ADDENDUM NO. 001

Architects Project No.: 23042

Project Name: Ralston Apartment Renovations

5 UNIT 1 BATHROOM ELEVATION WEST
A203 1/2" = 1'-0"

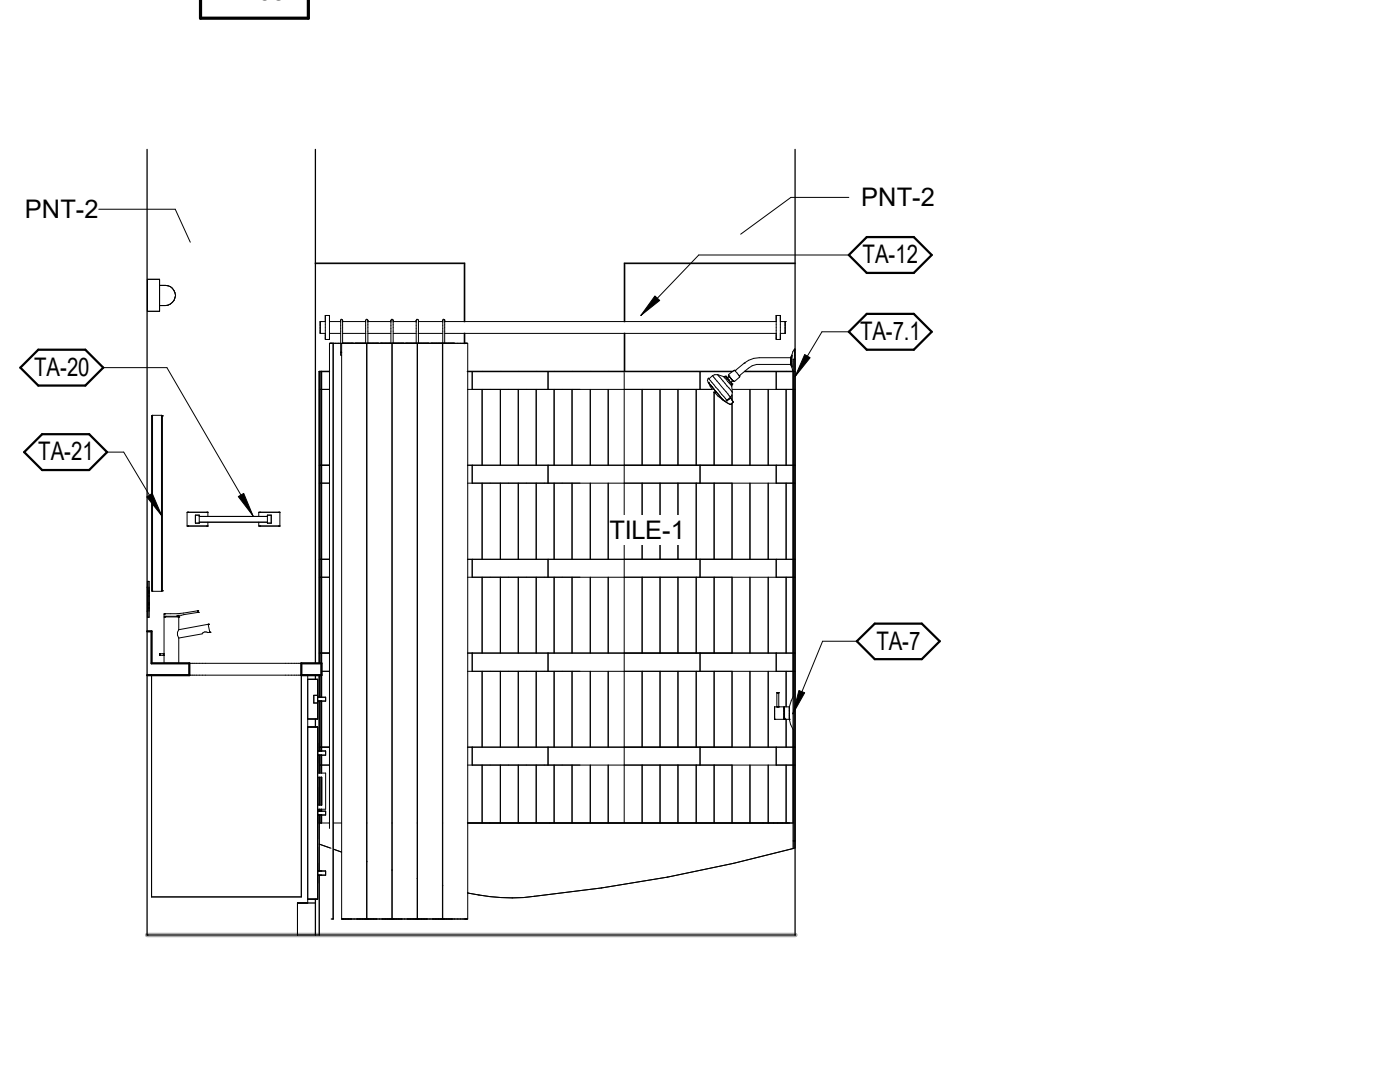
- a. 1/2" Counters
7. Is there a door hardware schedule available?
 - a. See added sheet A801 for hardware sets
8. The material list on sheet A203 shows Vinyl-1 should be located at the bathroom and kitchen floors, but the finish plan shows LVT-1 at the kitchen floors. Also, the material list shows Vinyl-1 as a vinyl tile, but it is a rolled vinyl product. Just want to make sure this is what you are looking for.

- a. Added dimensions to ceiling lights
 - b. Clarified dimensions on detail 3, general drawing cleanup.
 - c. Graphically showing TR-1 on the finish plan.

- d. Updated solid surface material information.
 - e. Vinyl updated description to match product data and clarified install locations. Added transition strip TR-1.

- a. Vinyl tile should just be in Bathrooms. See Addendum 01 for clarification on the color schedule.
9. What type of plumbing pipe are we to use on the project? PVC, cast iron, galvanized etc. Didn't see anything noted on the plans.

2 TYPICAL UNIT B - STUDIO FINISH PLAN
A204 1/4" = 1'-0"

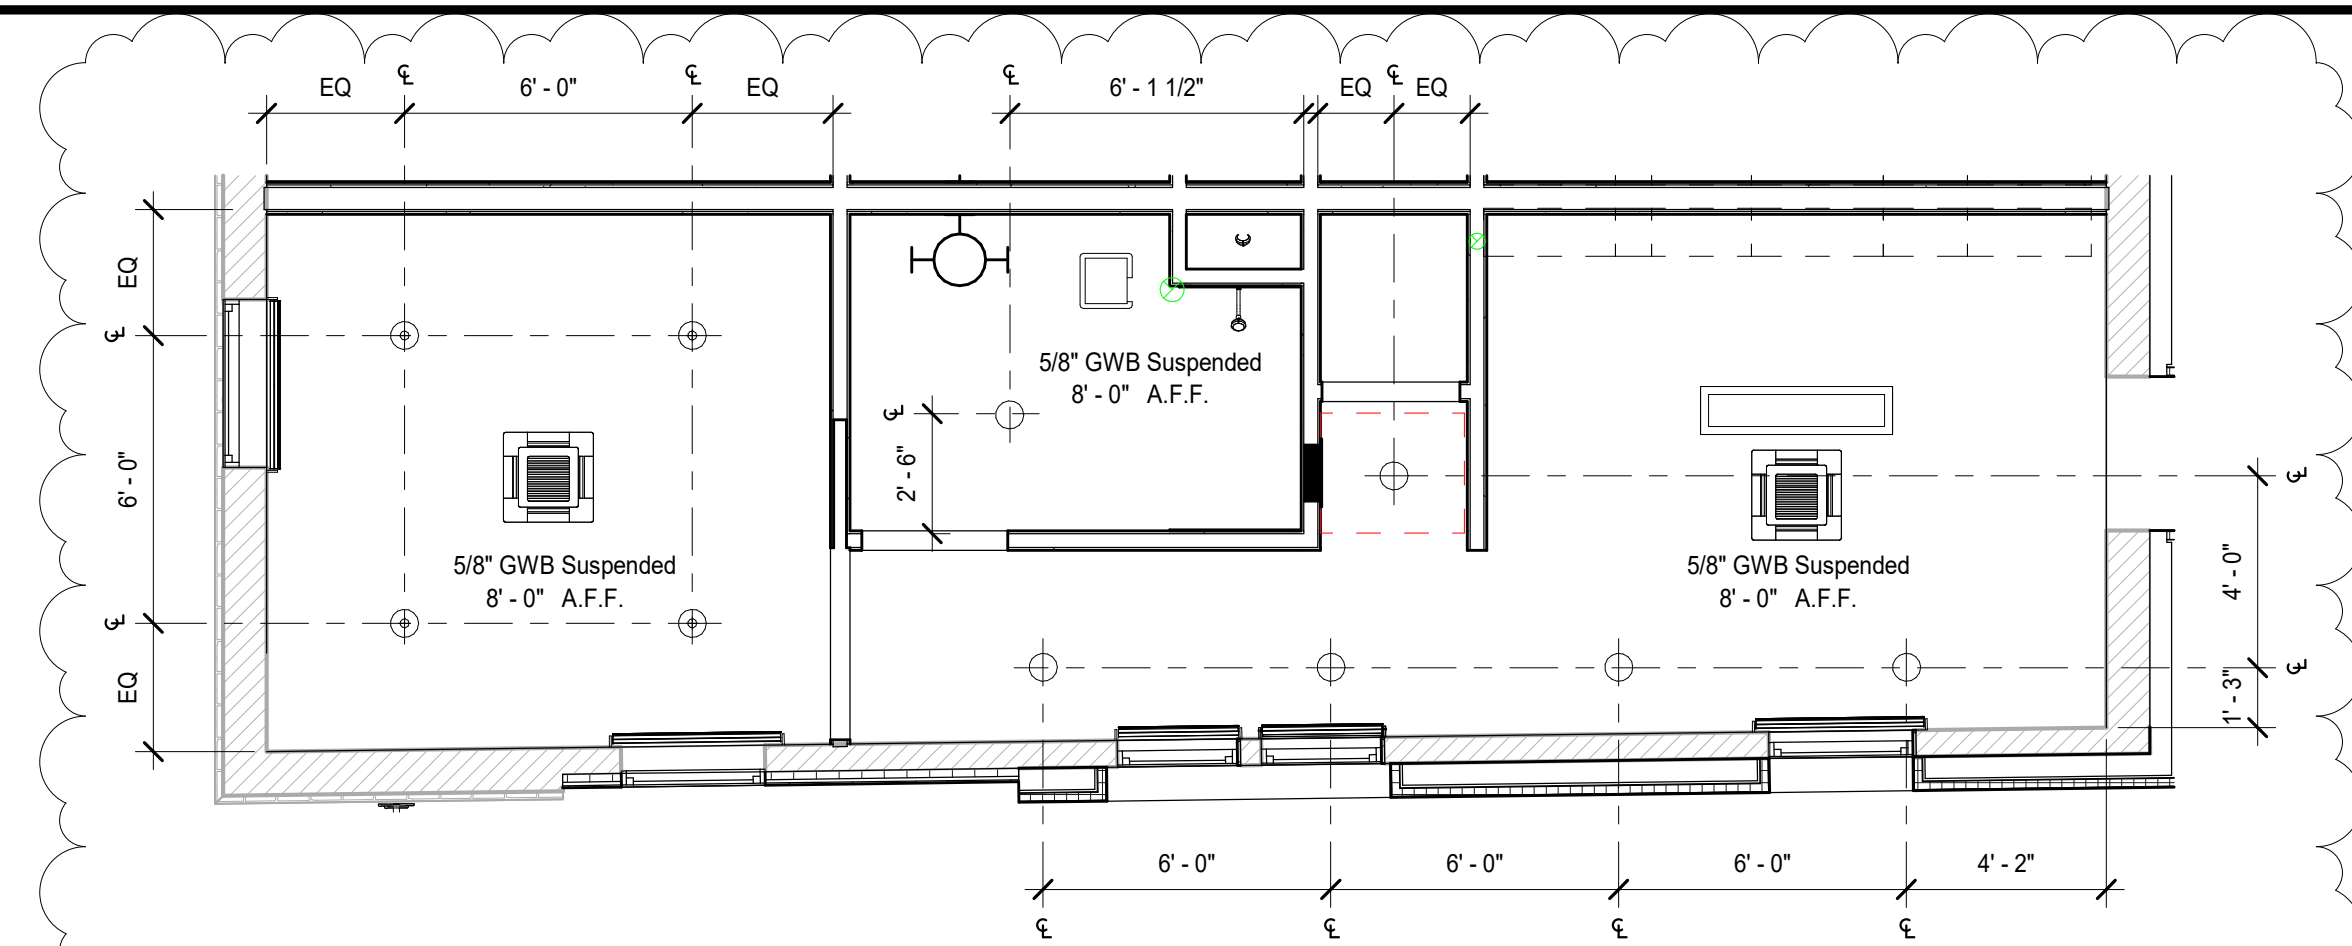
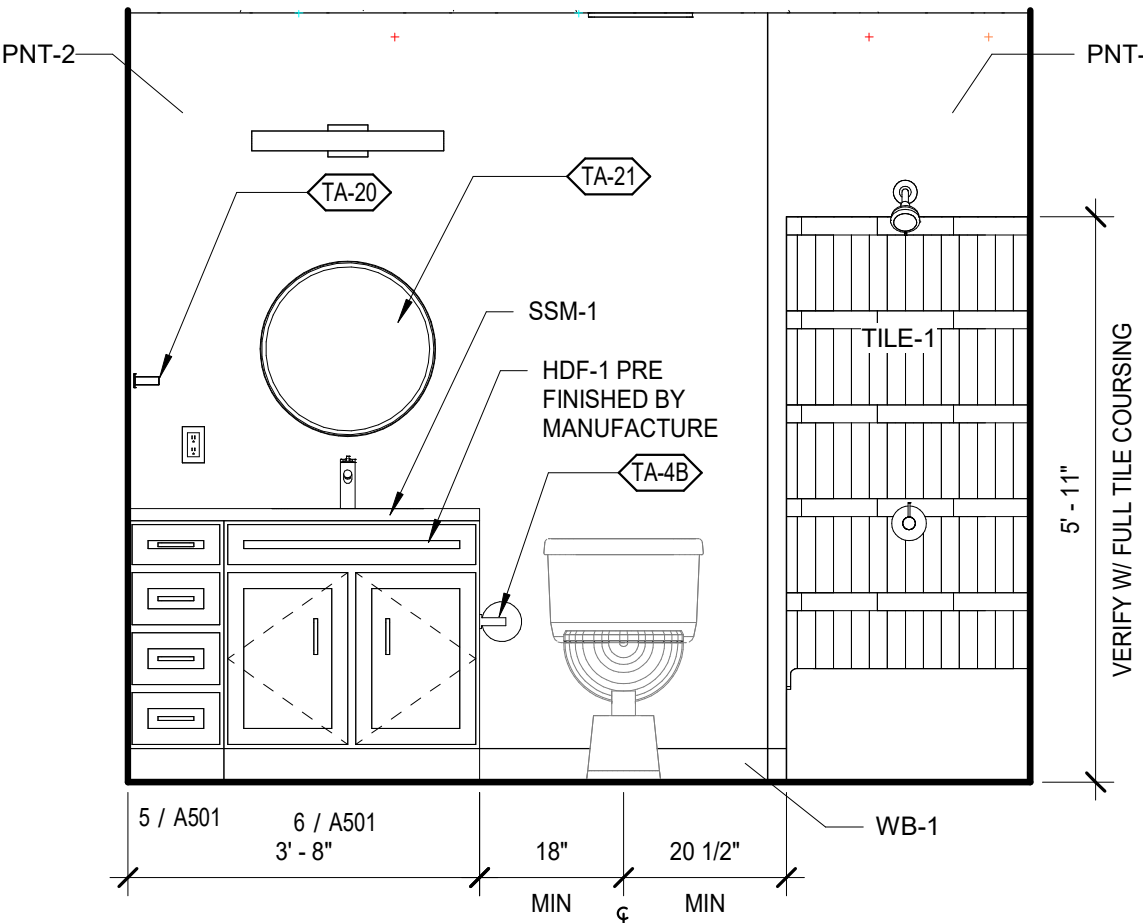
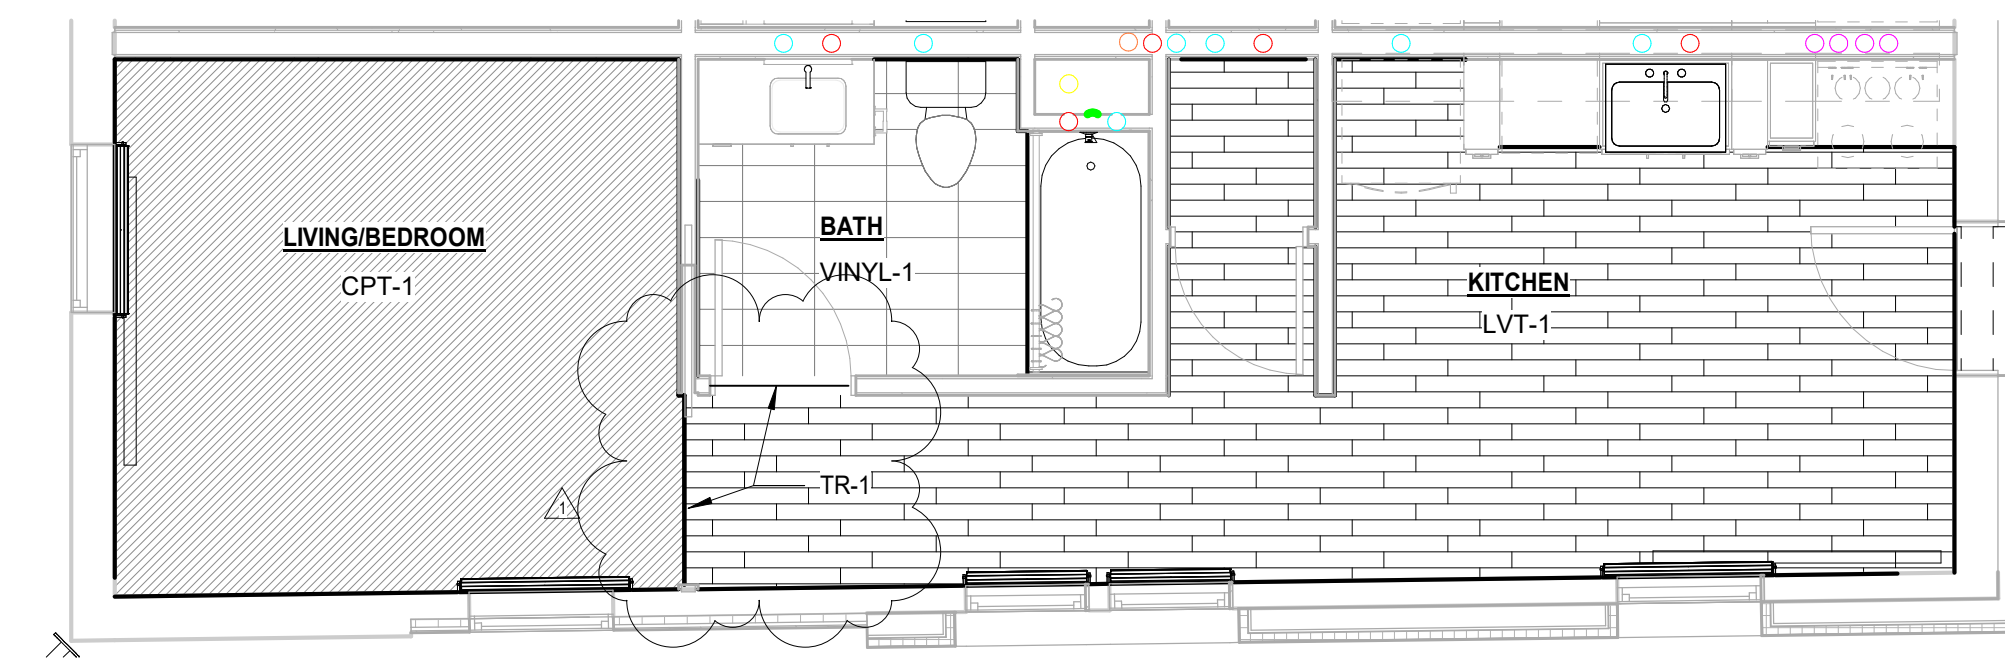
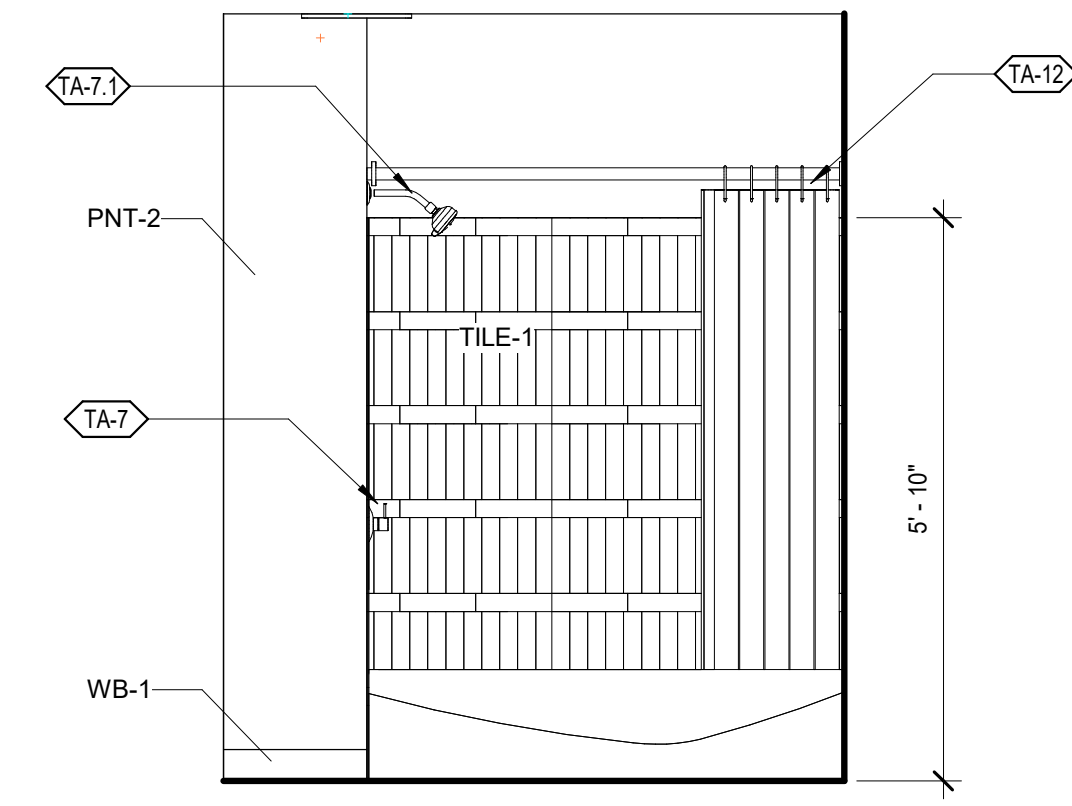
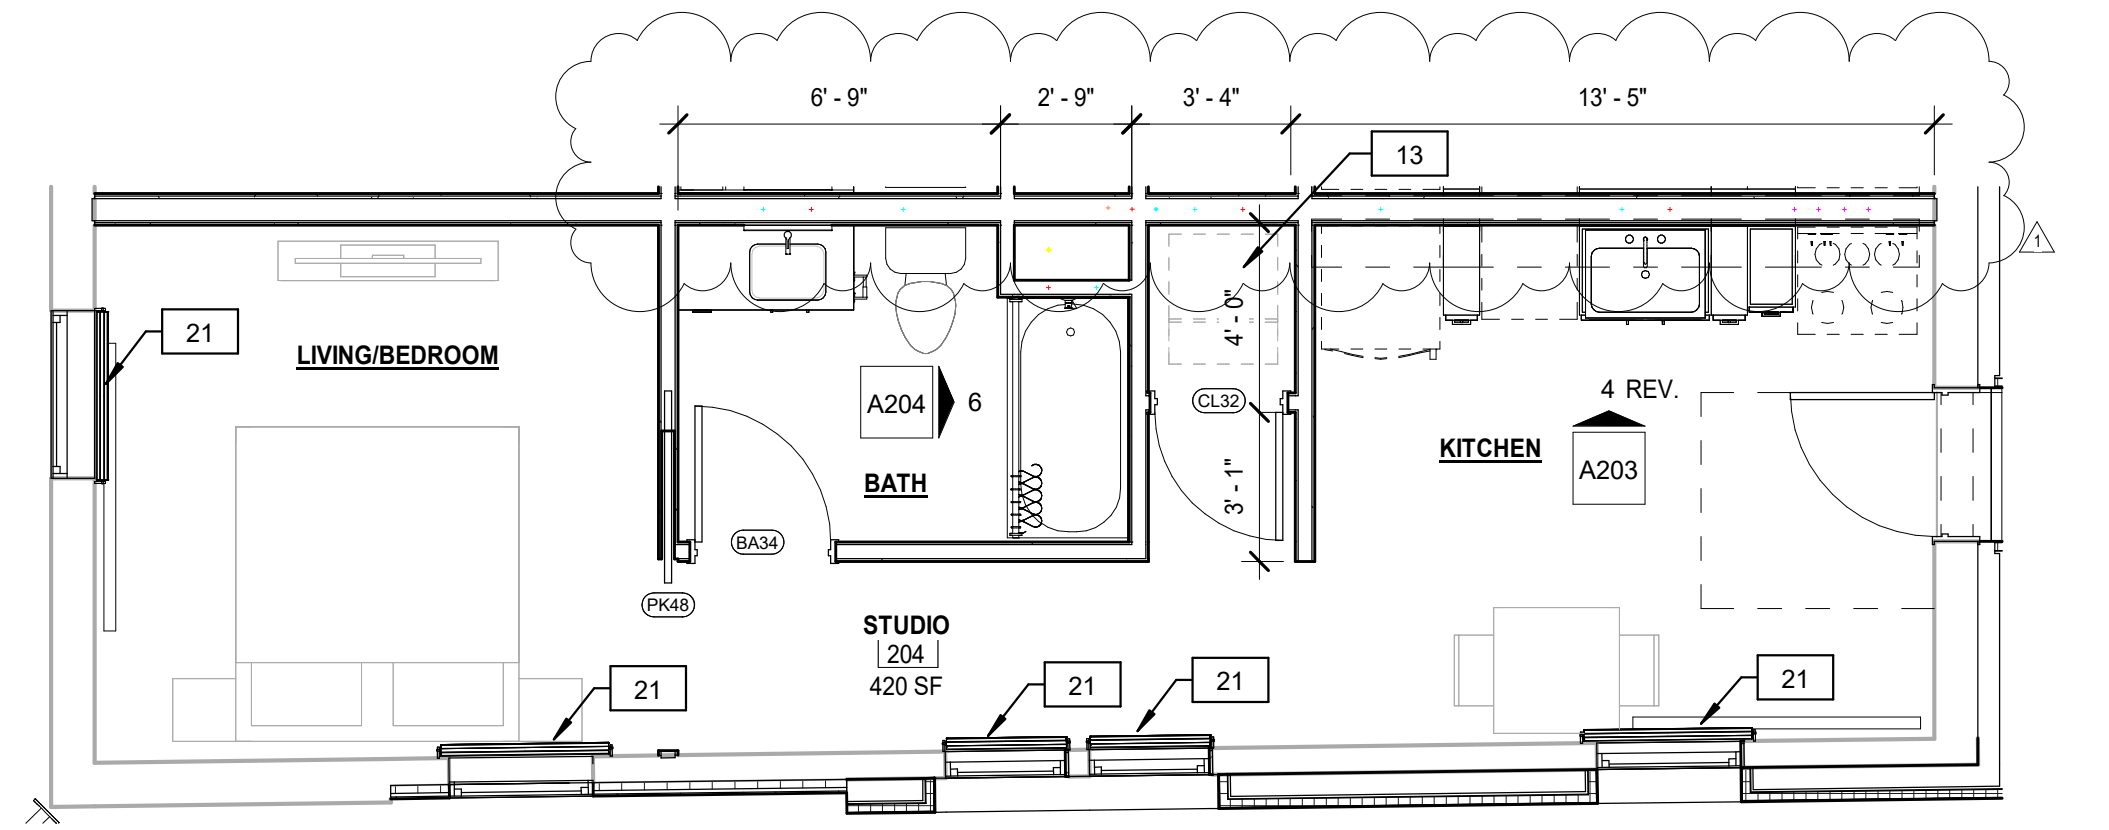
4. Sheet - A204 UNIT PLANS
 - a. Added clarification dimensions to reflected ceiling plan.
 - b. Clarified dimensions on detail 3, general drawing cleanup.

- c. Graphically showing TR-1 on the finish plan.
 - d. Updated solid surface material information.
 - e. Vinyl updated description to match product data and clarified install locations. Added transition strip TR-1.
